RECORD OF DECISION  
OPERABLE UNIT #4  
FLOODPLAINS/WETLANDS AREA  
FIELDS BROOK SITE, ASHTABULA OHIO

## OUTLINE

This responsiveness summary has been prepared to meet the requirements of Sections 113(k)(2)(B)(iv) and 117(b) of the Comprehensive Environmental Response, Compensation, and Liability Act of 1986 (CERCLA), as amended by the Superfund Amendments and Reauthorization Act of 1986 (SARA), which requires the United States Environmental Protection Agency (U.S. EPA) to respond to the comments submitted, either written or oral presentations, on the proposed plan for remedial action. All comments received by U.S. EPA during the public comment period were considered in the selection of the final remedial alternative for the FWA.

Figure 1: Fields Brook Superfund site

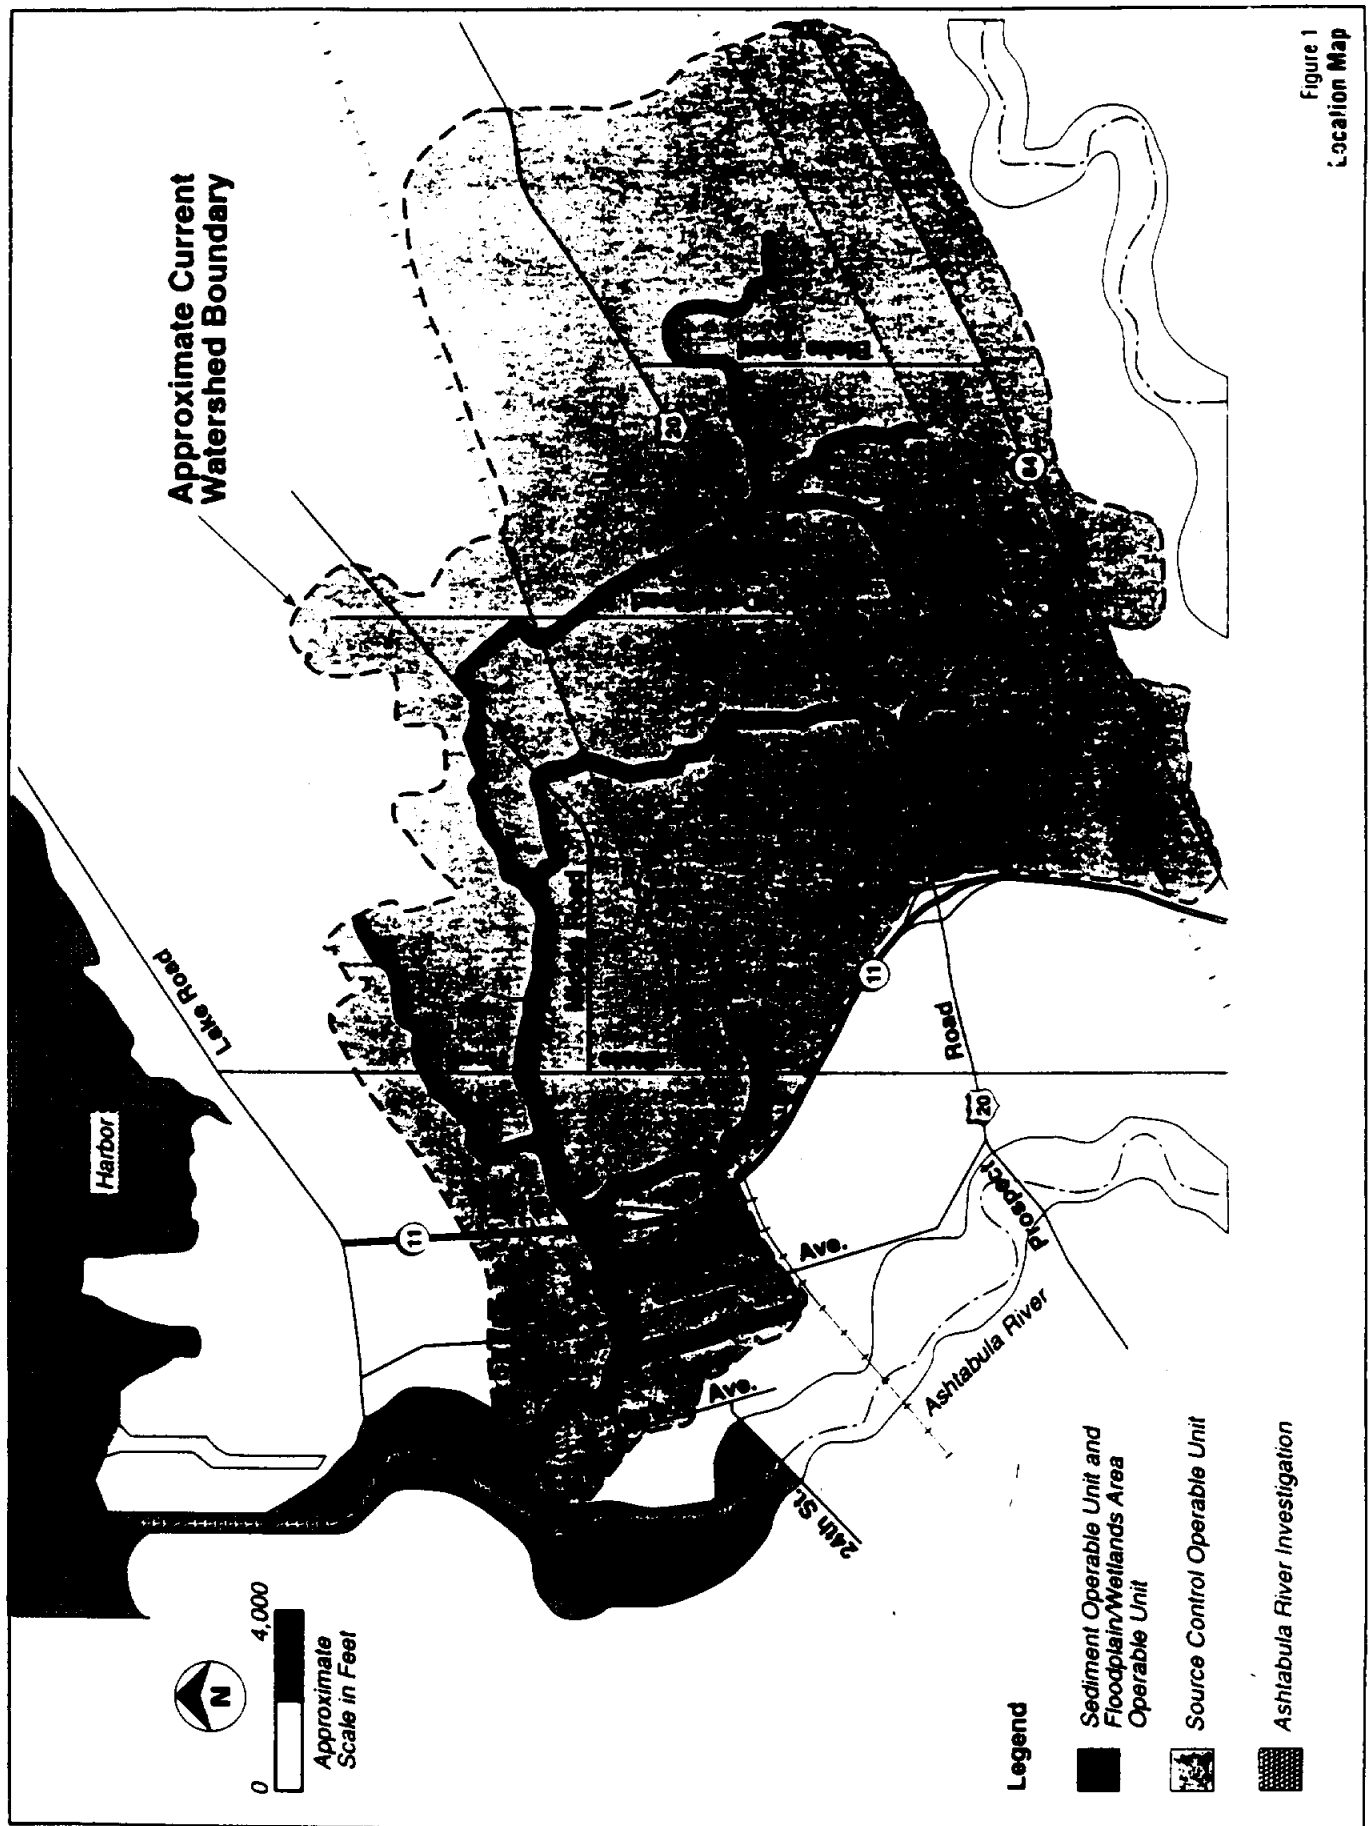
Comment: Figure 1 does not accurately depict the SOU and FWA investigation areas. The Source Control Operable Unit is not shown.

FIELDS BROOK  
 PROPOSED ON-SITE CONSOLIDATION AREA  
 CROSS-SECTIONAL VIEW

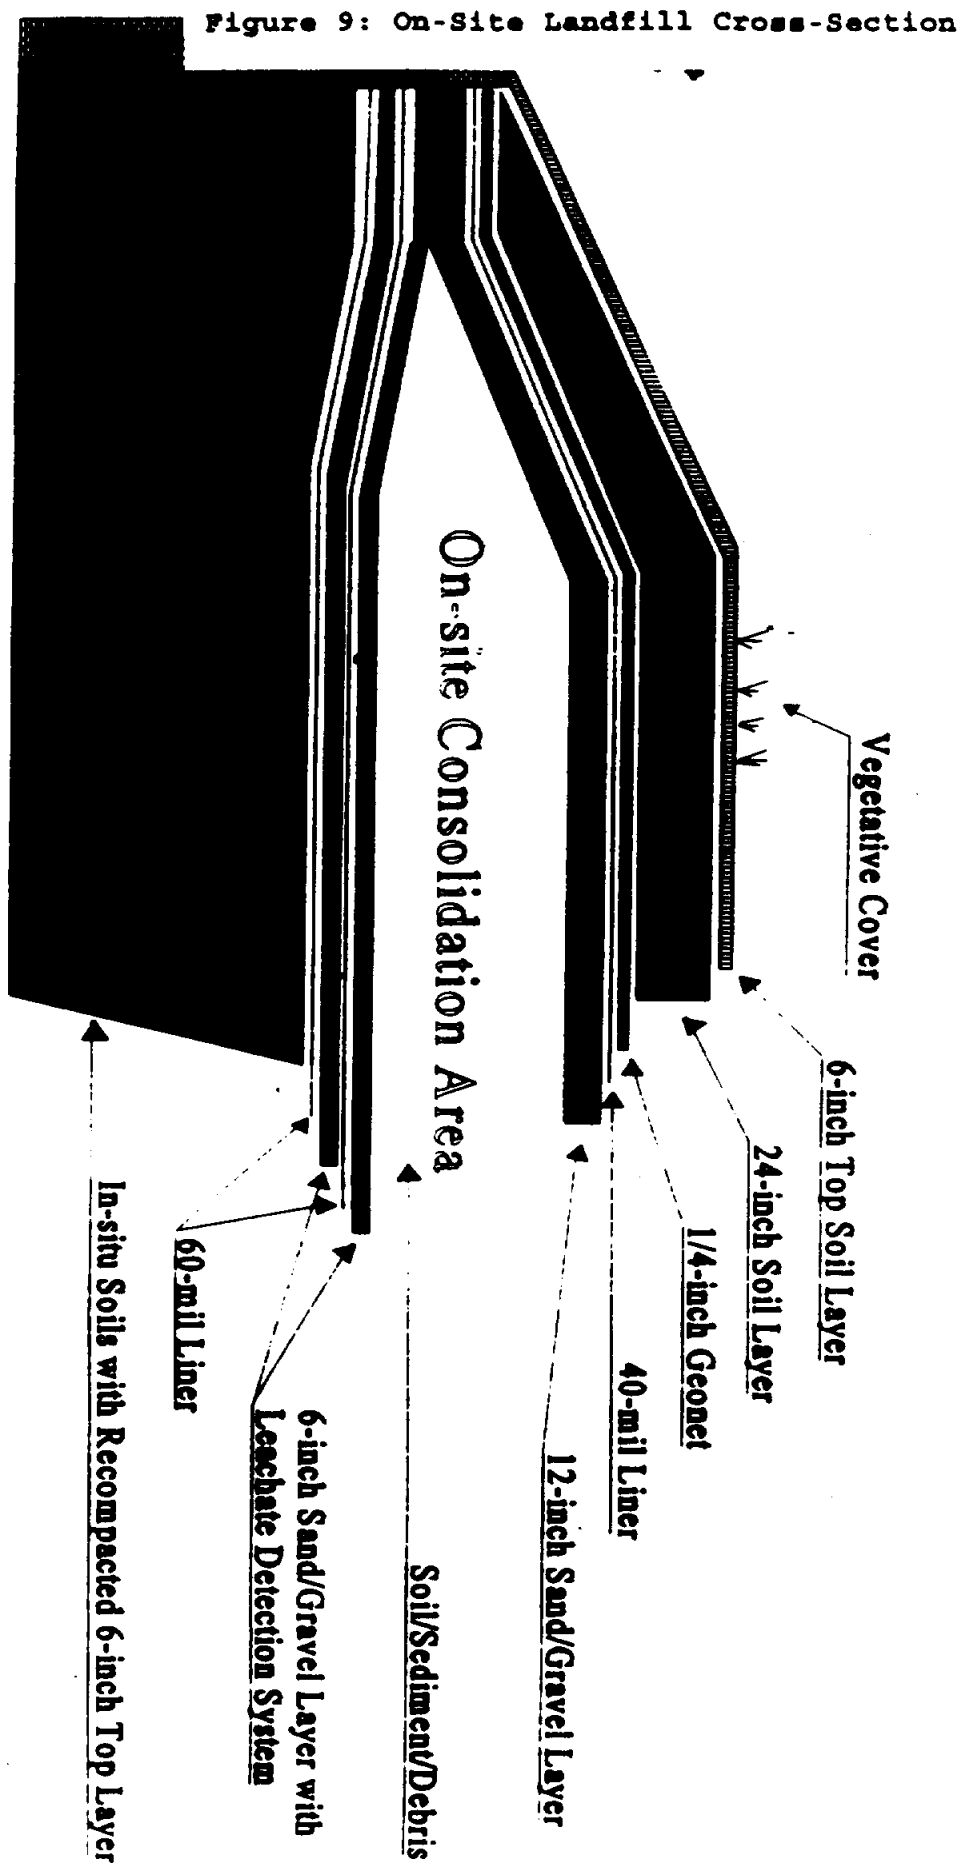
**a) Bottom Liner (from bottom to top, as indicated in Figure 9):**

**b) Cover (from bottom to top, as indicated in Figure 9):**
